**Field-Truthing and Monitoring of the Proposed PennEast Pipeline,
FERC Draft EIS, Docket No. CP15-558**

September, 2016

Prepared by: Delaware Riverkeeper Network

Figure 24: Temperature data for Alexauken Creek, away from ROW impacts

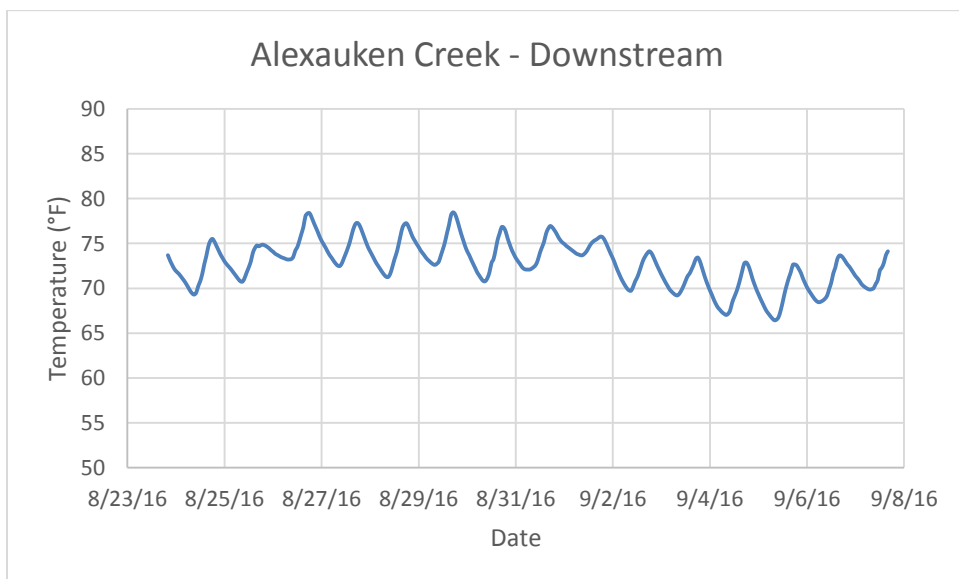
The data from the ROW logging station on the Alexauken show daily fluctuation. The temperatures range from 63.7 °F to 85.9 °F, with a mean of 73.7 °F. Whereas, the data collected from the other non-ROW station show much less fluctuations in temperature. For this station, the temperatures ranged from 66.4 °F to 78.5 °F, with a mean of 72.7 °F. Aquatic species generally have a preferred temperature range, and thrive in more stable temperature conditions. A ROW close to a waterbody means that air temperature would affect water temperature more rapidly. These rapidly fluctuating temperatures can wreak havoc on aquatic life. In comparison, a water body away from ROW and surrounded by forested land, would not be affected by air temperature as much, since the forest would act as a buffer to regulate water temperature. These trends can be clearly seen in the data collected for Alexauken Creek. The station by the ROW not only had a higher mean temperature, a much higher maximum temperature than the other station.
